25-17DA Venice Crossing

Staff Report

Address:	2001 Laurel Road
Request:	Requesting Amendment to Type 1 Buffer Along Northern property line approved through Design Alternative Petition 23-60DA
Applicant:	2001 Laurel, LLC and Randall C. Hurt, Joseph W., Hurt and Mary H. McMullen
Agent:	Jackson R. Boone, Esq, Boone Law Firm
Parcel ID:	0380-11-0002, 0380-14-0002, 0380-02-0001, 0380-09-0001, 0380-16-0001 and 0380-16-0003
Parcel Size:	82.81 ± acres
Future Land Use:	Mixed Use Corridor
Zoning:	Commercial, General (CG)
Comprehensive Plan Neighborhood:	Laurel Road Neighborhood
Application Date:	March 27, 2025
Associated Petition:	25-16PP

Map of Perimeter Buffer as Proposed through Design Alternative No. 25-17DA

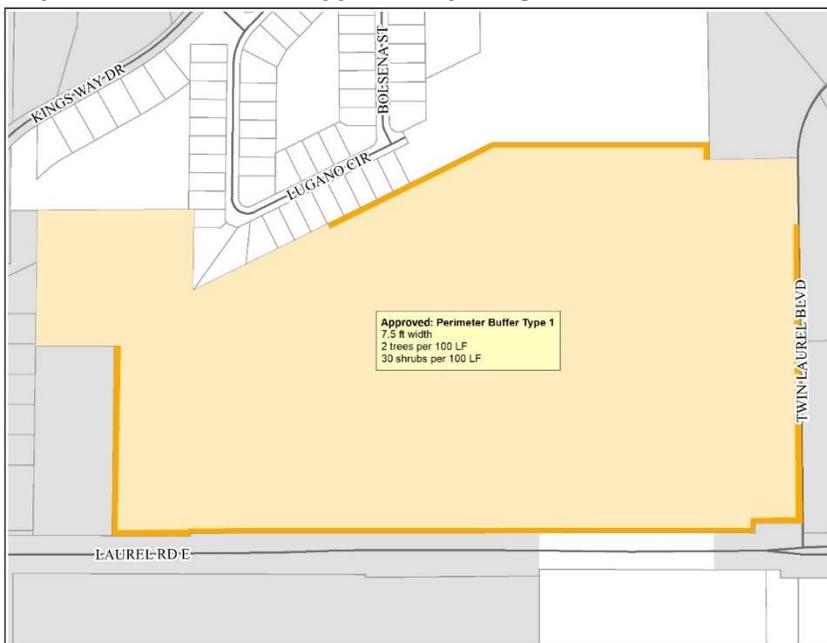
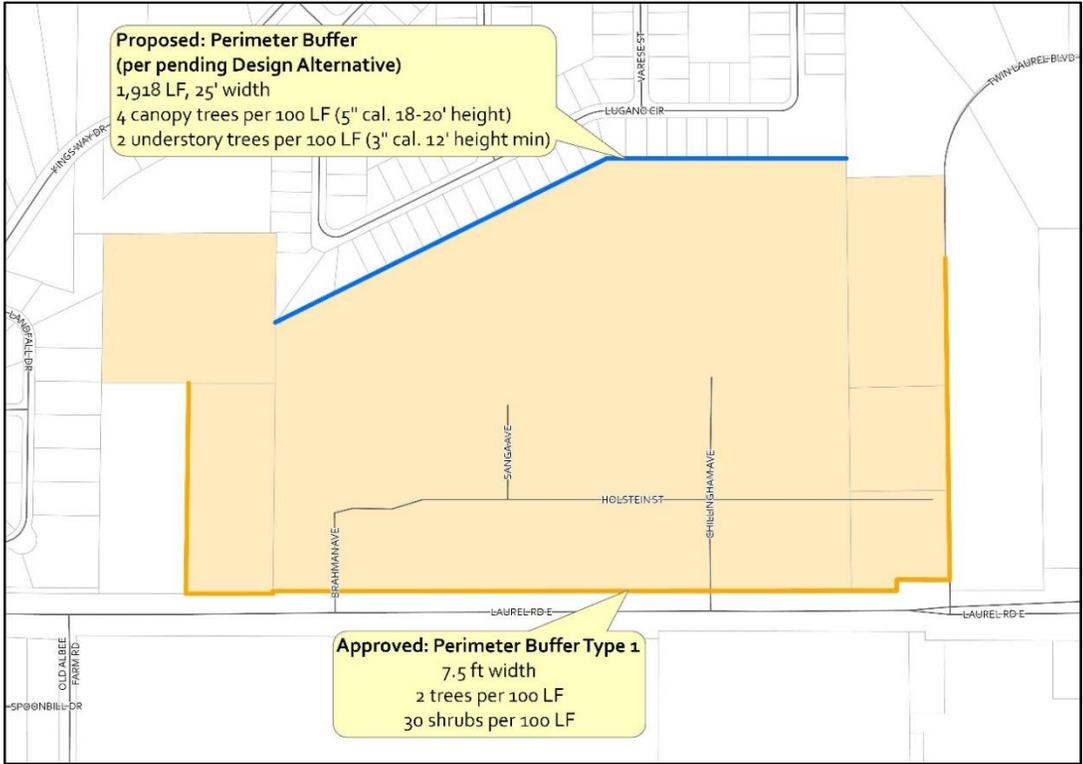
Staff Response: CG remains the zoning for the entirety of the property, which is most similar to the CM in the current code. Typically under 4.3 Perimeter Buffer Type, a type 4 buffer would be required if considering the compatibility table for Proposed Use of CM and Existing Use of RSF to the north. The applicant is requesting a perimeter buffer that is 25' in width and provides more than the required tree plantings (canopy and understory trees), in lieu of a buffer with a fence and shrubs. The applicant states that there is an existing 6' fence for Cassata Oaks and an additional fence or shrubs would not be visible to nearby residents.

Staff Response: Please see the maps of the currently approved perimeter buffers and the applicant requested perimeter buffer.

Summary Staff Comment: The requested design alternative still provides the visible elements of a larger buffer type, while providing larger canopy and understory trees. Requiring an additional wall/fence and hedges would create areas of dual fence lines which would be duplicative.
